AMERICAN CAR AND FOUNDRY CO.
31-21007
GALVANIZED
STEEL DETAILS

A.R.L.X. 1001-2000

3300A
3300
LOT

HOPPER FRAME SUPPORT
3 1/2" x 2 1/2" x 3/8" L x 2'-4 5/8" O.H.S.
4 - PER CAR
702 2 - AS SHOWN
703 2 - REVERSE

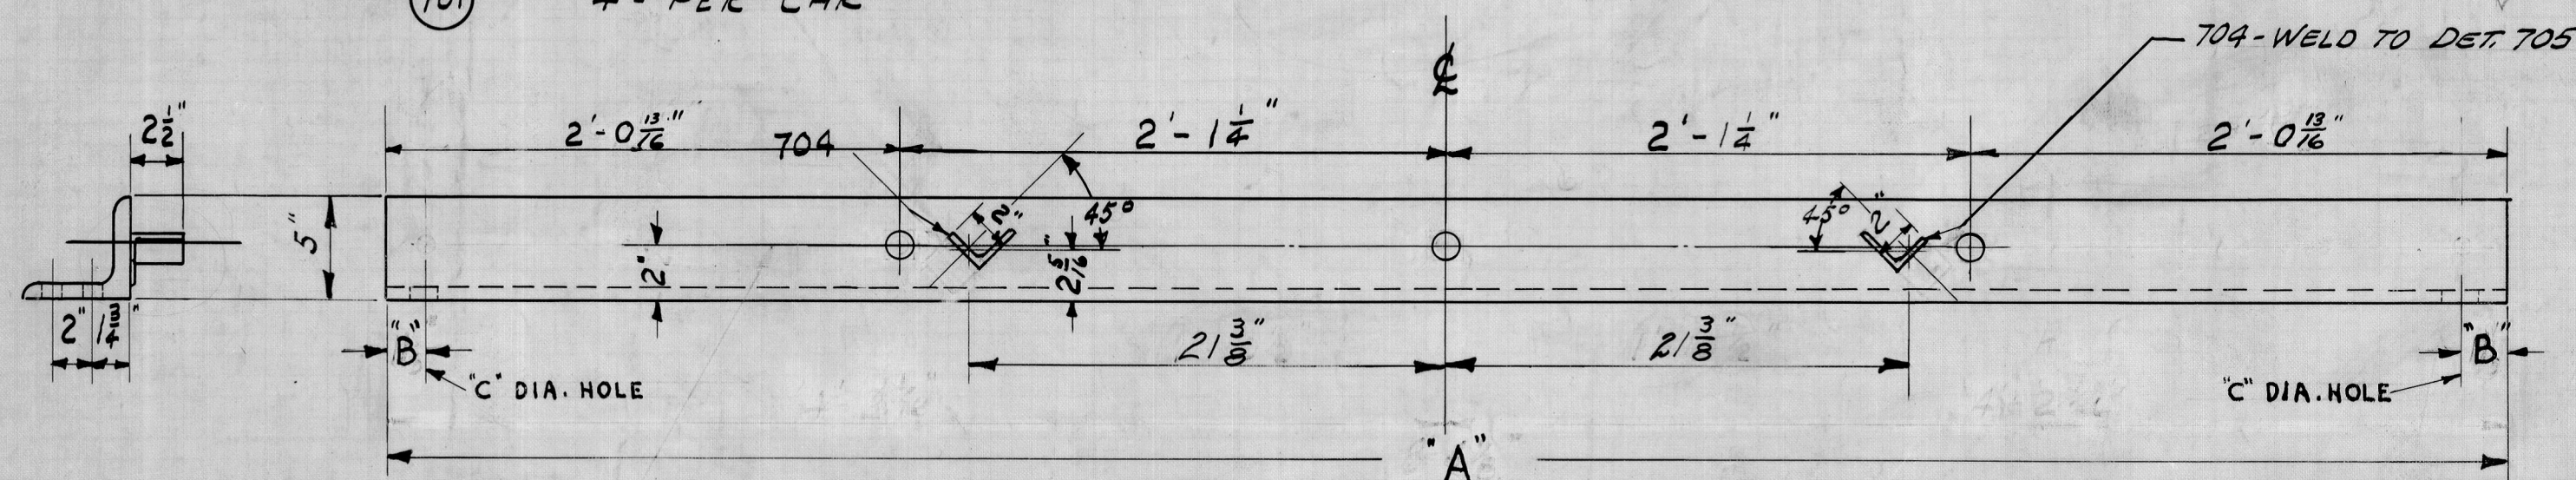
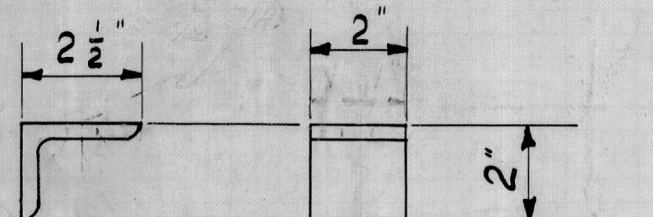
11-29-48 "F" - 9/16" HOLE OMITTED IN TOP OF TEMP. 702 & 703. HOLES ON 1 1/4" GA. LINE TEMP. 702 & 703 WERE 1 1/16" & 3/16" DIA.
11-30-48 "E" - CHANGES - DET. 705, 706 - PER SHOP LTR. 11-23-48
11-15-48 "D" - 3300 - SHOP CHANGES - LTR. 11-2-48
10/11/48 "C" - 3300 - SHOP CHANGES
10/6/48 "B" - HOLE DIA. REVISED IN DET. 702 & 703; NOTE ADDED
10/1/48 "A" - DET. 702-703 - 3/16" HOLE RELOCATED, DET. 701 - HOLES ADDED.
10/1/48 DET. 704-705-706 - HOLES REMOVED. DET. 705 NUTS REMOVED

HOPPER FRAME SUPPORT
3 1/2" x 2 1/2" x 7/8" L x 2'-4 5/8" O.H.S.
4 - PER CAR
702 - 2 - RS SHOWN
703 - 2 - REVERSE

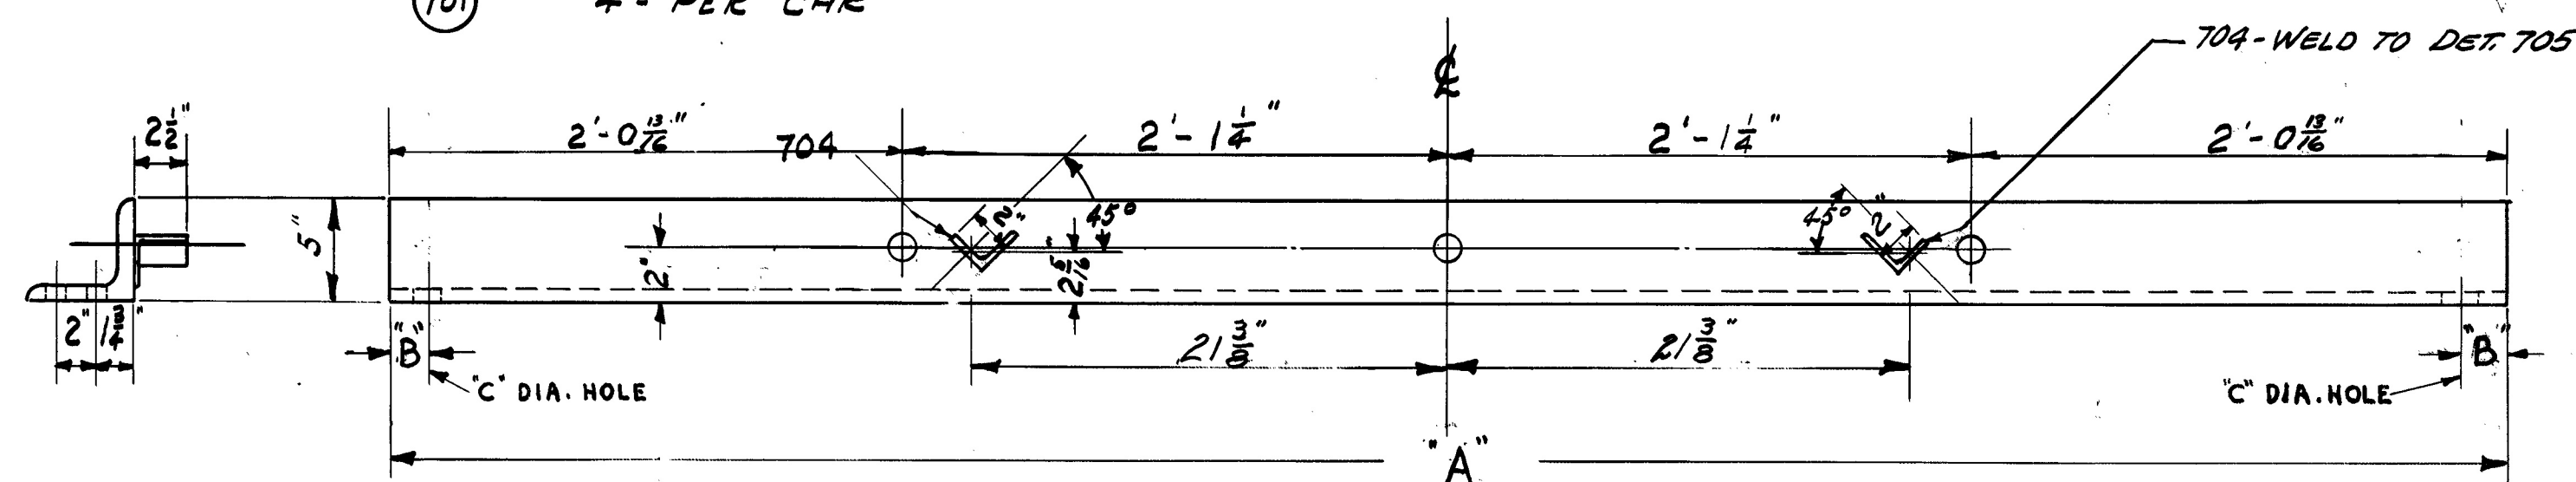
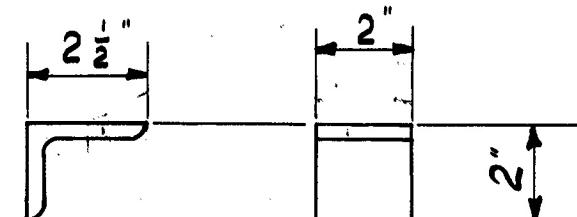
FILE 11-23-48
E - 9/16" HOLE OMITTED IN TOP OF TEMP. 702 & 703. HOLES ON 1 1/2" GALV. LINE TEMP 702 & 703 WERE 1 1/8" & 3/4" DIA.
E - CHANGES - DET. 705 706 - PER SHOP LTR. 11-23-48
D - 3300 - SHOP CHANGES - LTR. 11-2-48
C - 3300 - SHOP CHANGES
B - HOLE DIA. REVISED IN DET. 702 & 703; NOTE ADDED
A - DET. 702-703 - 3/16" HOLE RELOCATED, DET. 701 - HOLES ADDED.
DET. 704-705-706 - HOLES REMOVED. DET. 705 NUTS REMOVED
